To: Barangaroo Central Assessment Team

OBJECTION TO CENTRAL BARANGAROO MODIFICATION 9 APPLICATION, (Miller's Point and Observatory Hill) - Aqualand – SSD- Infrastructure NSW - Section 75W Modification Request; Application No MP 006 0162 MOD 9

Statement

Figure 4. Sydney Harbour SHR Nominations AILA NSW :Visual Catchments map, 7 May 2018.

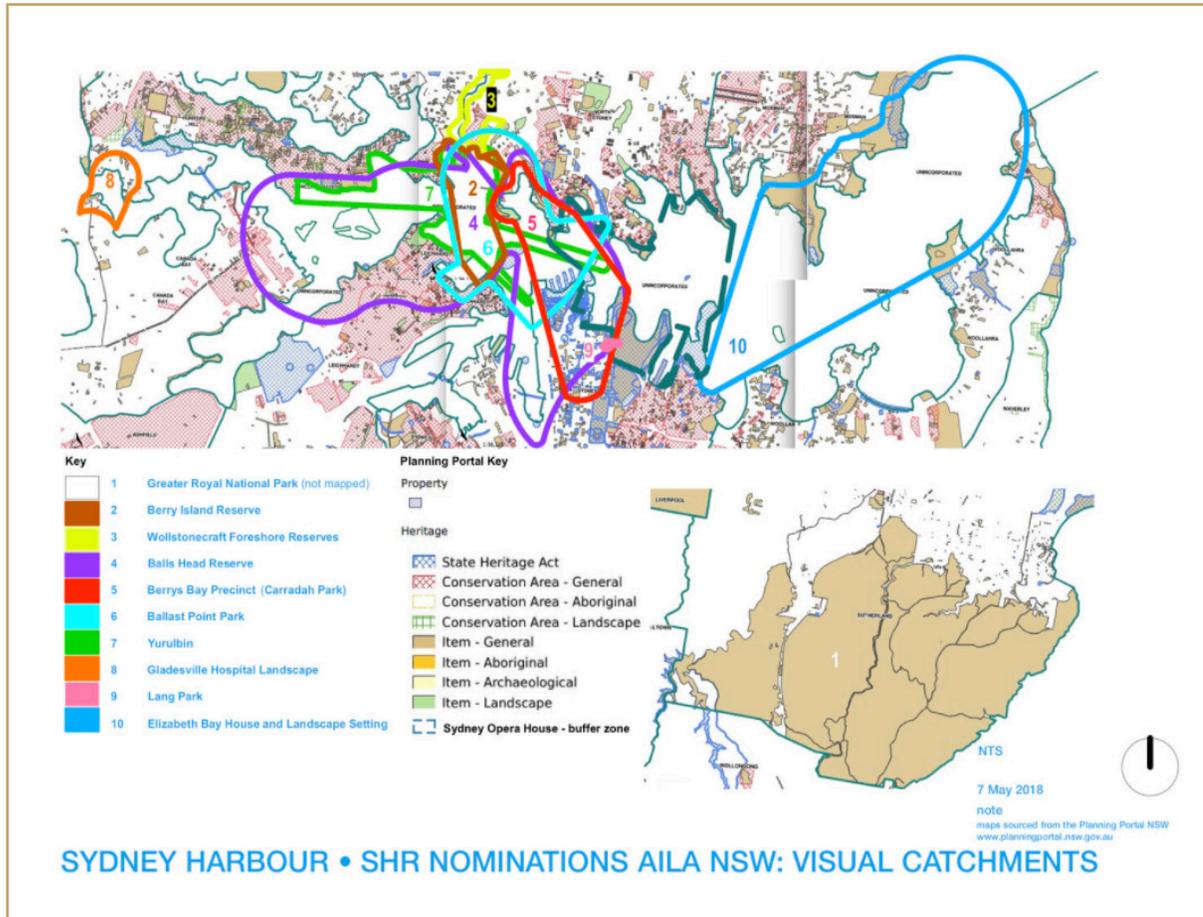
The impact of the proposed development on important visual connections between all of the identified 'Green Necklace' sites; Badangyi, Balls Head Reserve, Berrys Bay Precinct, the Coal loader, Observatory Hill, Balmain and the Bays Precinct and the water itself, must be assessed as part of the proposal. Refer to the [Sydney Harbour SHR Nominations AILA NSW :Visual Catchments map, 7 May 2018.](#)

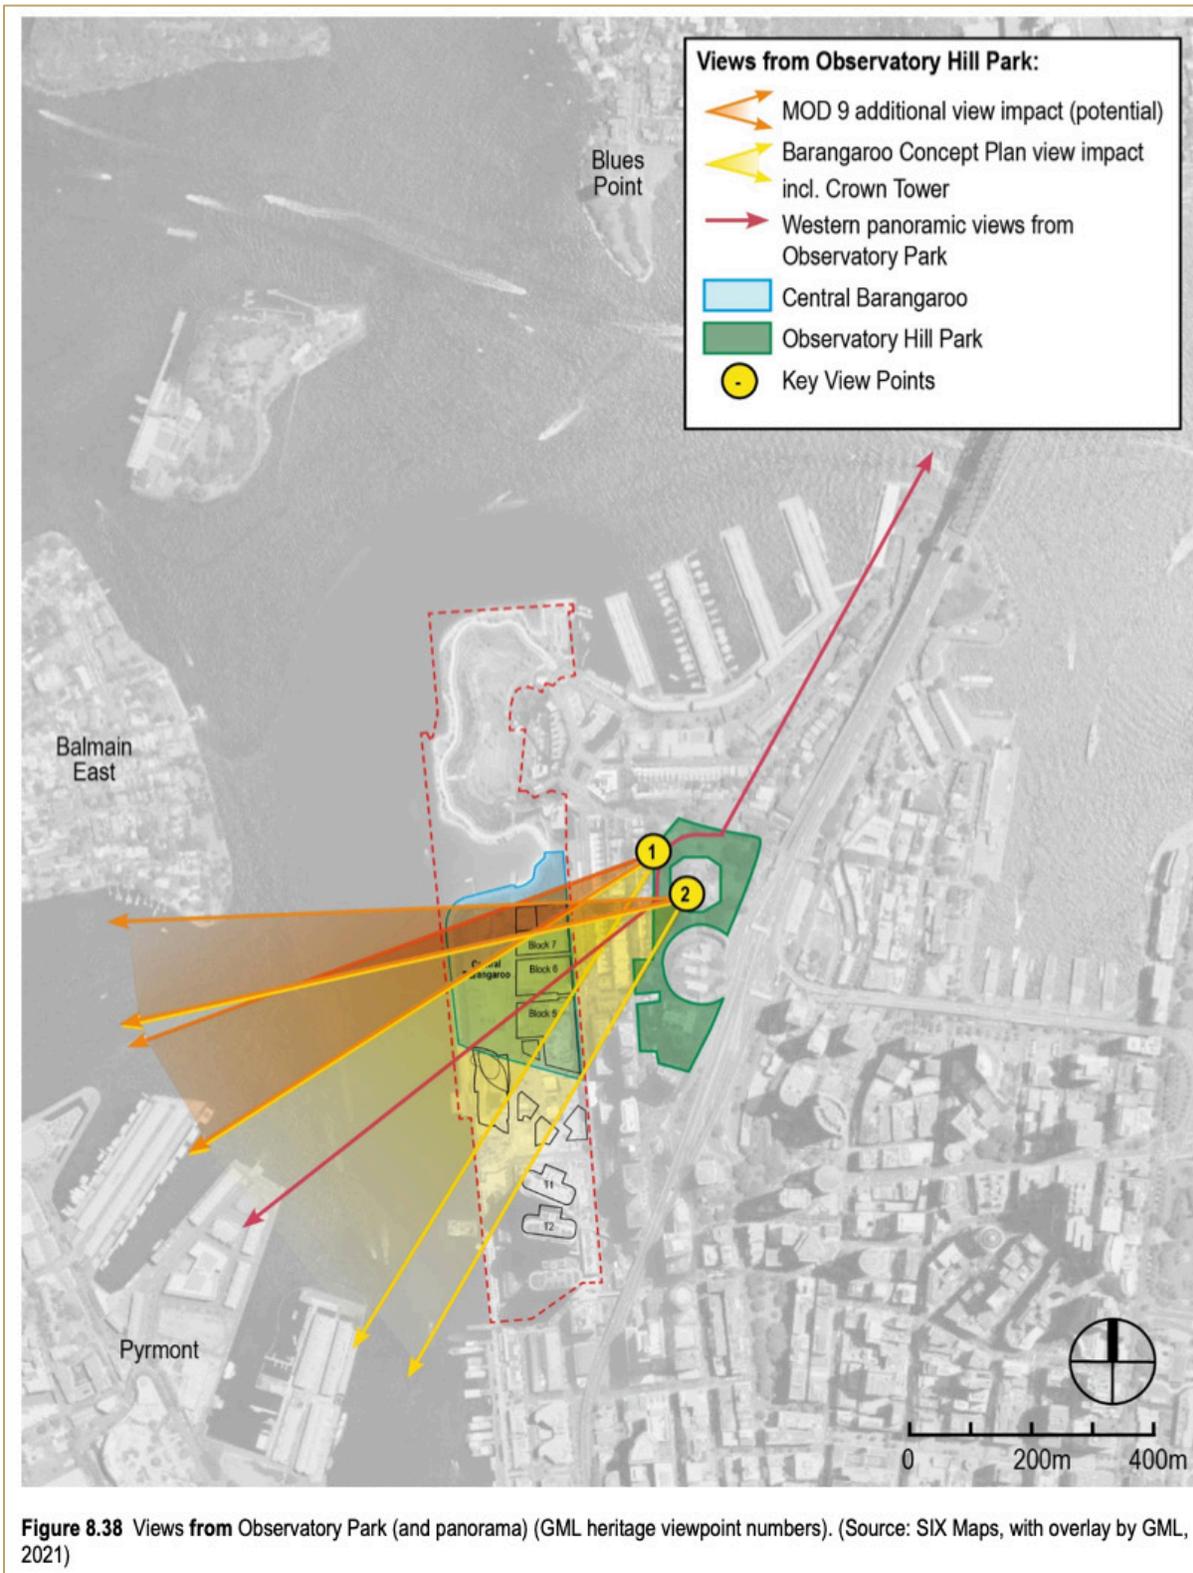
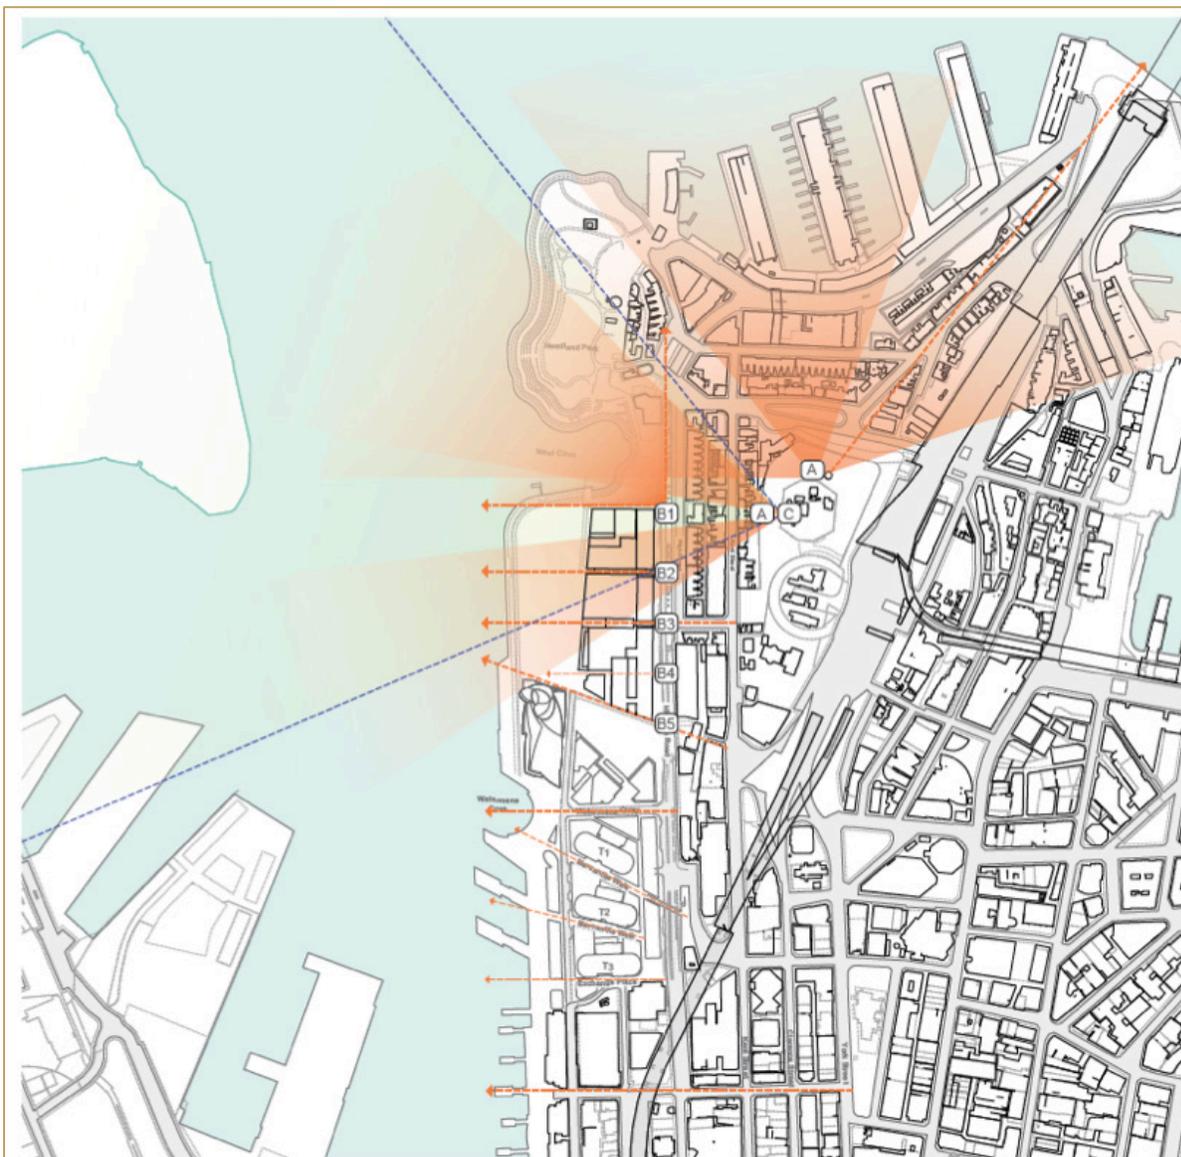
yet the view mapping, Figures 8.37, 8.38 and 8.39, and concluding remarks of the Heritage Assessment and Impact Statement (HAIS) on page 158 demonstrate that appreciation of these qualities will be impossible;

'Views to Observatory Park from Ballarat(sic) Park and Pirrama Park will involve an additional minor loss of views to the tops of trees in Observatory Park and the Observatory itself, as proposed under MOD 9'.
